Technical Note

Project No: ITB11347
Project Title: Mill Lane, Hatfield Heath
Title: Response to ECC Consultation: UTT/22/1261/FUL
Ref: ITB11347-008A TN
Date: 4 November 2022

DRAWING No: ITB11347-SK-002

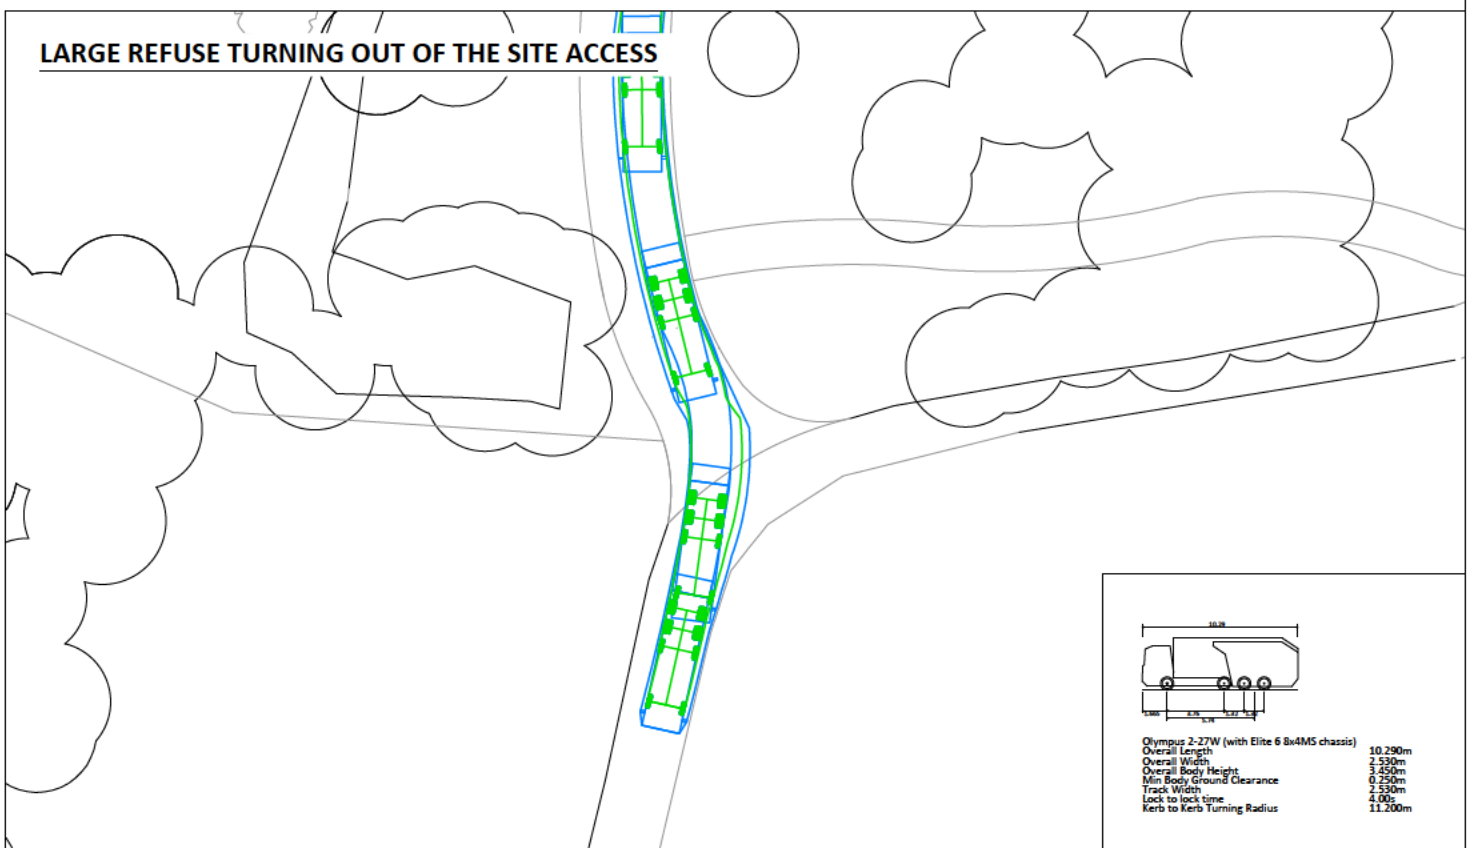
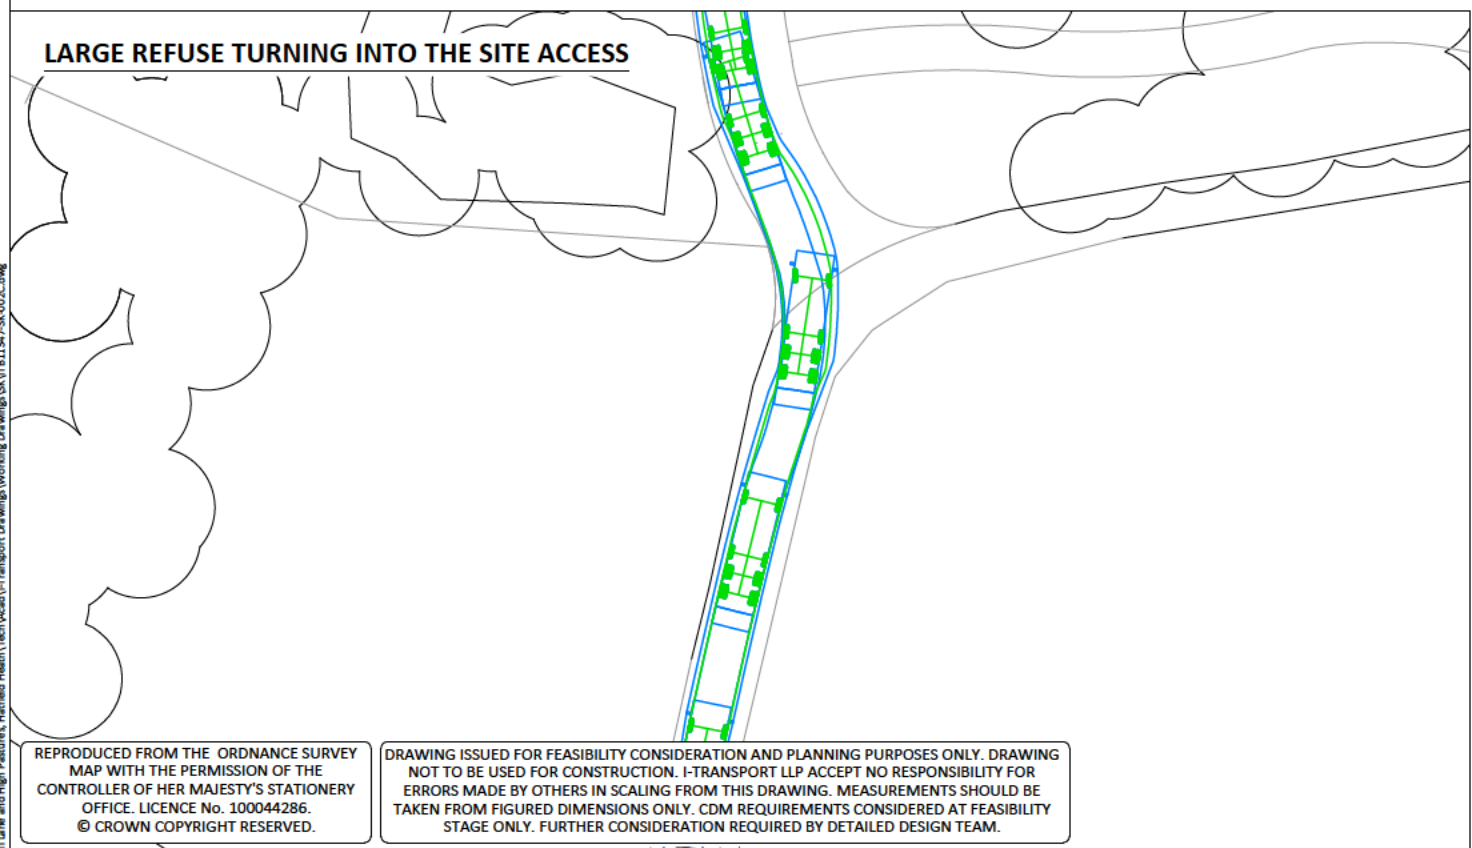
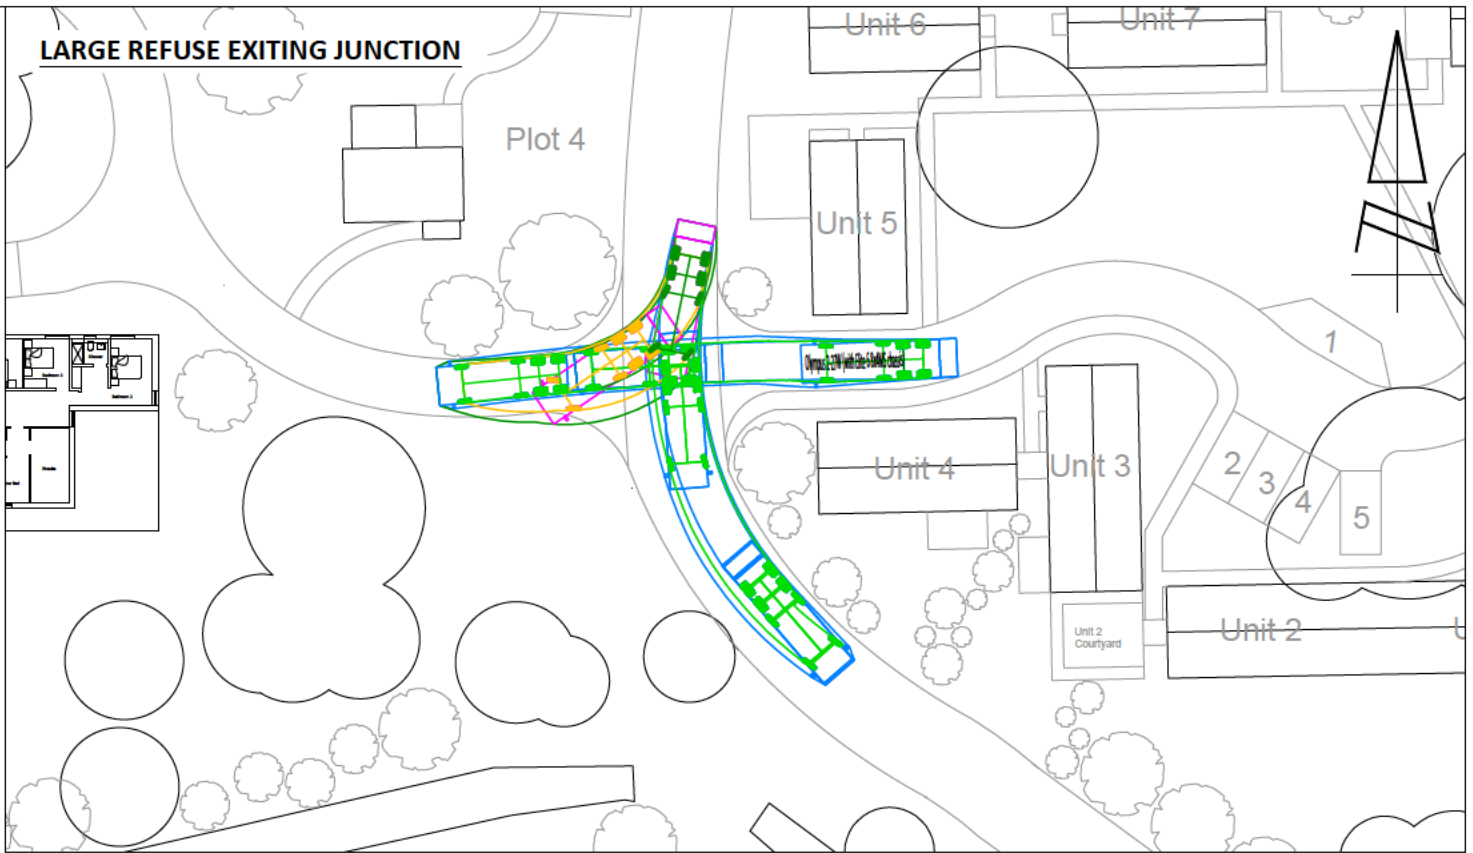
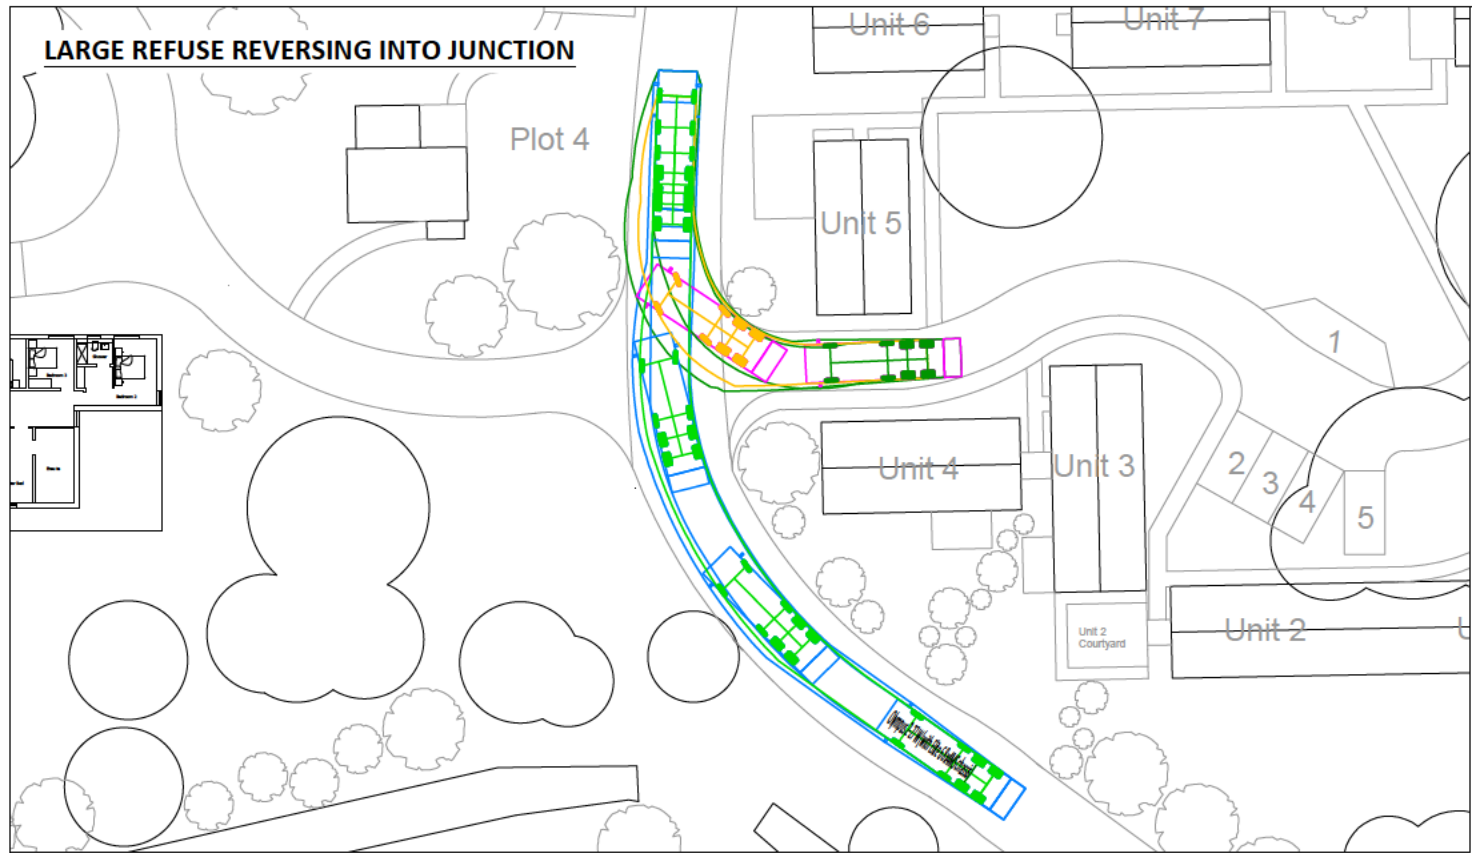
- c Swept path analysis for a large car and a van should be provided for the access to the terraced housing.*
- d The swept path analysis for a refuse vehicle has been provided for the site but it uses a vehicle of a smaller length than that used by UDC refuse team. This should be repeated with correct vehicle, which has a length of 10.325m and a turning circle of 22.4m, the speed of the vehicle should be provided and should be a reasonable speed for the type of road.*

3.4 The update to the refuse vehicle tracking using ECC's suggested vehicle has been undertaken as per point (d) and is shown in Drawing ITB11347-SK-001 Rev G and Drawing ITB11347-SK-002 Rev C. The swept path analysis shows that the revised refuse vehicle can enter, manoeuvre and turn within the site and exit the site in forward gear along the main access road.
